**Subject: Traffic Impacts Peer Review Initial Findings Letter
Sanctuary at Manchester by the Sea, MA 40B Development**

In accordance with our Agreement of December 18, 2020, Stantec Consulting, Inc. is pleased to submit this initial letter pertaining to ***Task 1 – Conduct a peer review of the Traffic Impact Assessment (TIA) prepared for a Proposed Multi-family Residential Development on School Street at Manchester by the Sea.***

The referenced TIA is dated September 2020 and was prepared by Vanasse & Associates Inc. (VAI) of Andover, Massachusetts on behalf of the Project Proponent, SLV School Street, LLC.

Site Parking Layout Issues of Concern

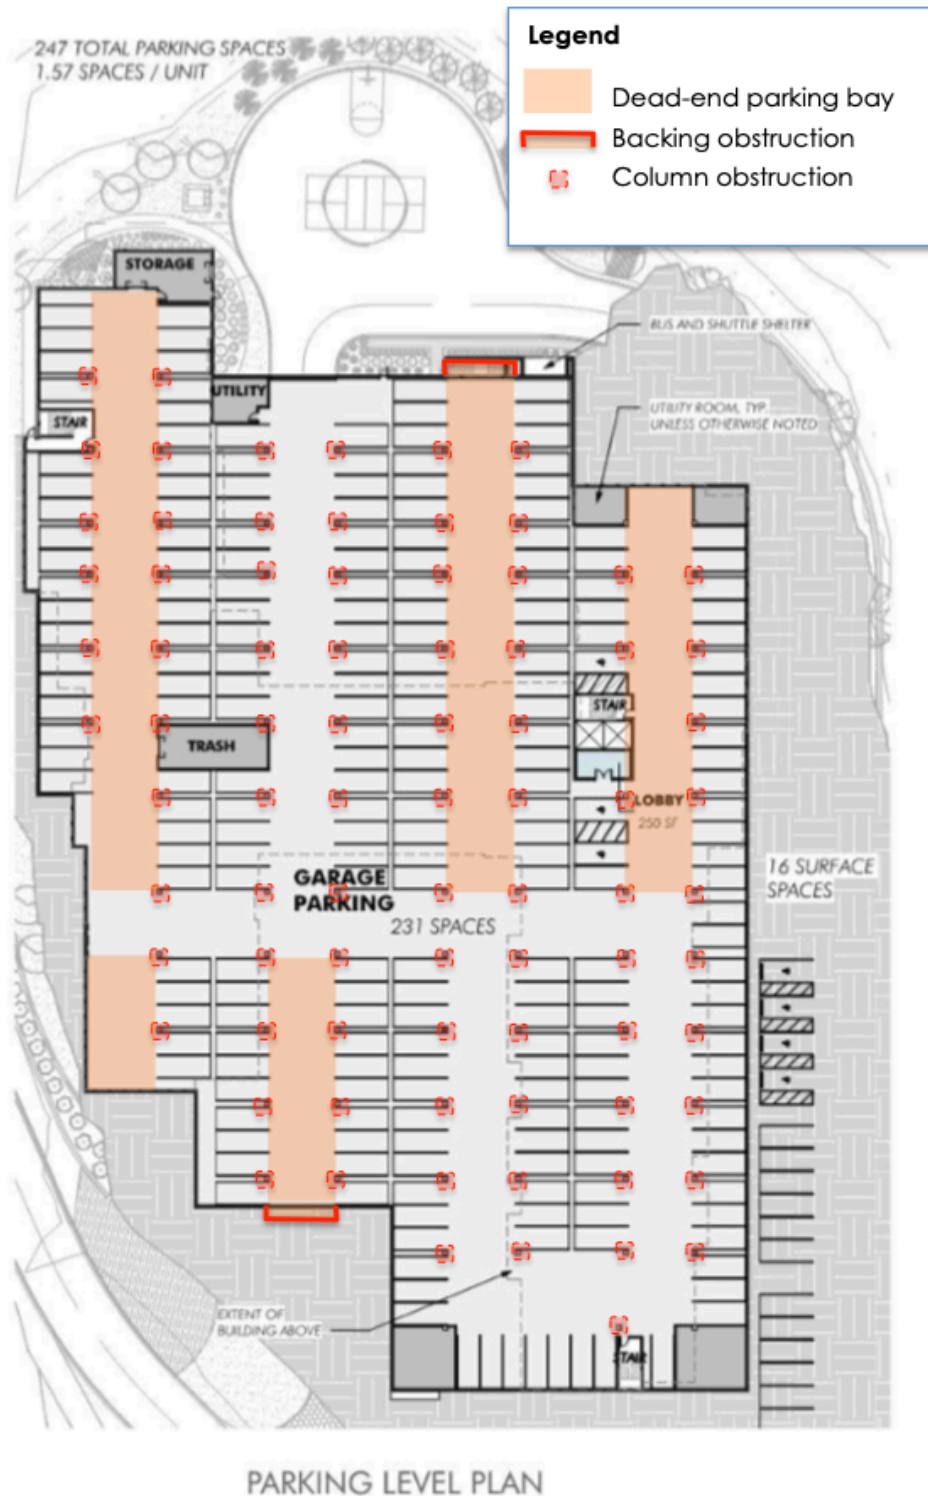
Augmented by an illustration on the next page, comments below pertain to circulation issues that warrant some discussion with the Applicant for safe garage operations, in order of importance:

- **Dead-end parking bays.** The site plan proposes a total of five 'dead-end' parking bays. Such dead-end bays are problematic and are not recommended. It is not always possible to see whether a space is occupied at the entrance to a dead end parking bay, even if all spaces are assigned to individual units. Additionally, if for any reason, an emergency vehicle must enter the garage, the absence of driving continuity could present a hazardous circulation condition.

- **Backing obstructions.** At least four parking spaces are located too close to walls for safe backing maneuvers. If possible, an indent of at least 6 feet should be considered to create a backing area for vehicles when exiting the spaces in question. We note that this issue is eliminated if there are no 'dead-end' parking bays.

- **Structural columns.** While not always practical to do so, it is best to minimize the use of structural columns in garages because they create safety hazards for users adjacent to them and a high incidence of 'fender-benders'. It is necessary to add some additional clearance areas around structural columns for the safety of motorists driving into or out of their spaces and walking between vehicles to or from their parking spaces, usually 2 feet additional width on each side of the column or, essentially a total envelope of 5 feet around the columns. The garage plan submitted calls for the installation of more than 80 columns that will directly affect the users of approximately 160 of the 231 parking spaces in the garage. The envelope around the columns seems to be 2 feet rather than 5 feet in width.
